**POSITION OF OWNER ASSOCIATION
INTERVENORS**

RE: Ginn-La Marina, LLLP, LTD, et al. v. Flagler County, et al.
DOAH Case No: 10-9137

MEMORANDUM

To: Al Hadeed, Scott Glass, Wayne Flowers, Steve Geller
From: Michael Chimento
Date: November 24, 2010
Subject: Reynolds Proposed Settlement Agreement

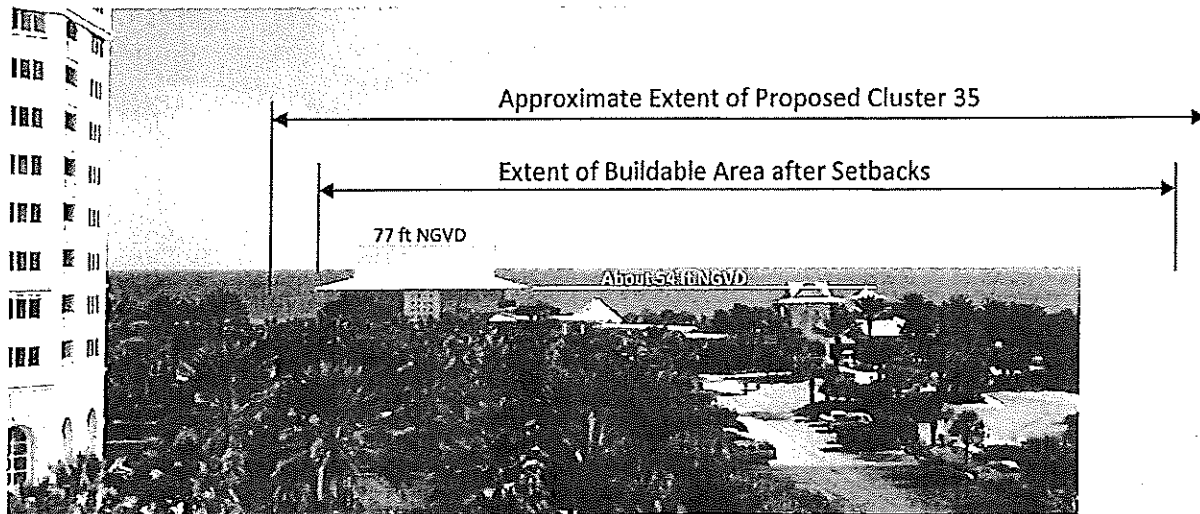
RESPONSE: We believe that the area of the existing Hammock House is the appropriate location for the golf clubhouse if it is not incorporated into the other facilities on cluster 35.
